RECEIPT DATE: 12/13/18 **ONSITE SEWAGE DISPOSAL SYSTEM** P 564095

APPROVAL DATE: 3/5/19 SEC **PERMIT: CONSTRUCTION** A \_\_\_\_\_

PROPERTY ADDRESS: 13619 Curtis Vista Way

<b>TITLE:</b> ONSITE SEPTIC DESIGN SYSTEM PLAN	
<b>HOUSE TYPE:</b> CLIFTON PARK - ELEVATION A	
<b>DATE:</b> AUGUST, 2018	<b>PROJECT NO.</b> 2627
<b>SCALE:</b> AS SHOWN	<b>DRAWING</b> 1 <b>OF</b> 3

See attached sheet for  
as-built drawing

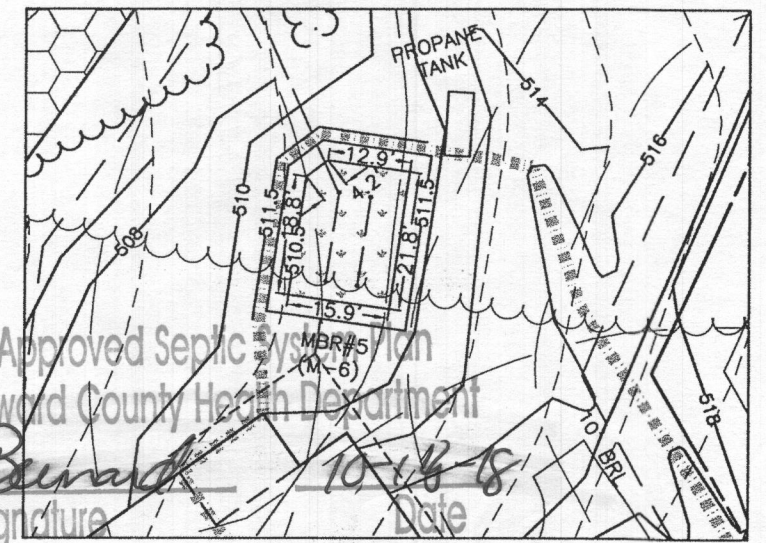
\* test. Alarm sounds, pump pumps effluent to D-box. Ran water in the house, runs to tank clear. (SC)

PRE-CONSTRUCTION:

1/3/19 Met S. Carroll on site for layout. Tanks + SDA corners staked. Spot elevations at house and tank and sewer line will make tank with 1% fall BUT final grading/swale is not yet complete. S. Carroll will talk to builder a/b getting that done before installing tanks + sewer line. SDA has 1" of fill in upper area - remove prior to laying out trenches. (SC) 1/7/19 S. Carroll removed fill in parts of SDA - 5" total in spots. Shot contour + laid out 2 x 78' trenches. (SC)

INSTALLATION: 1/9/19 T1 complete + left open for inspection - 3' wide and 3.5' to stone. S. Carroll digging T2 3' wide and 7' bottom. Using laser to check depths. (SC) 1/10/19 T2 complete + left open for inspection - 3' wide + 3.5' to stone. Septic tank set on site while pump tank was set and no obvious cracks on bottom or sides. Pump + float valve installed, > 1-day storage above alarm float. (SC) 1/9/19 D-box set, connected to pump tank + trenches. (SC) 1/16/19 S. Carroll installing sewer line. 1% fall, line bedded with #57 stone. Line to be sleeved under driveway turn around. Run water in house prior to ICOP + verify flow at tank - biopond + LP tank to be installed and machinery will drive over line. (SC) 1/22/19 House connection made. Need to verify flow from house to tank. (SC) 3/5/19 Met S. Carroll for pump + alarm. (SC)

**PLAN VIEW**  
1" = 50'

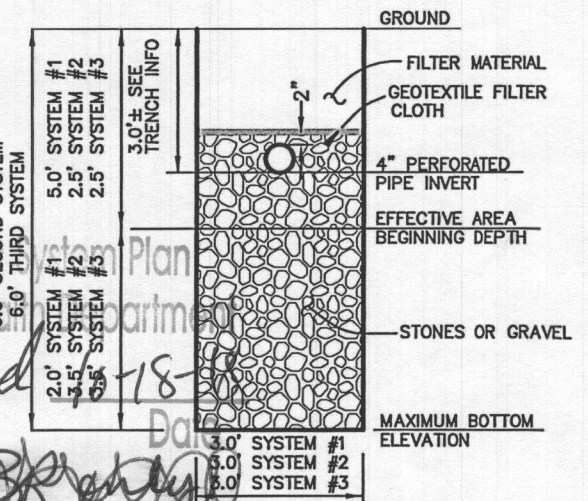
*\* Calculations are correct system however fall may have to be adjusted in field*

**PROJECT:** BRIGHTON MILL II *Or revised in field*  
**LOT 5**

**PLAN VIEW**  
 1" = 50'

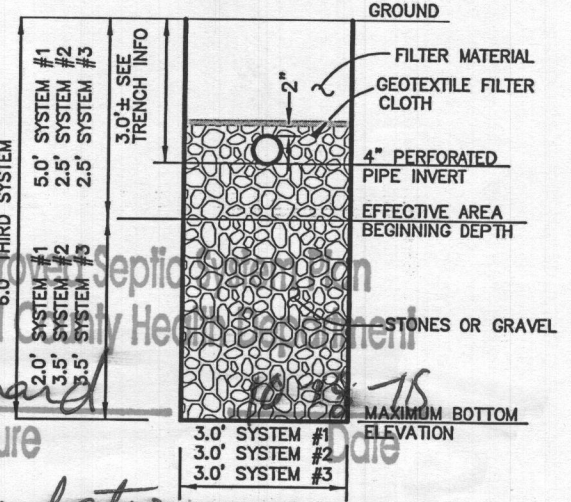
*Howard County Health Department*  
*Signature*  
*Calculations are correct however fall and system may have to be adjusted or reversed in field*
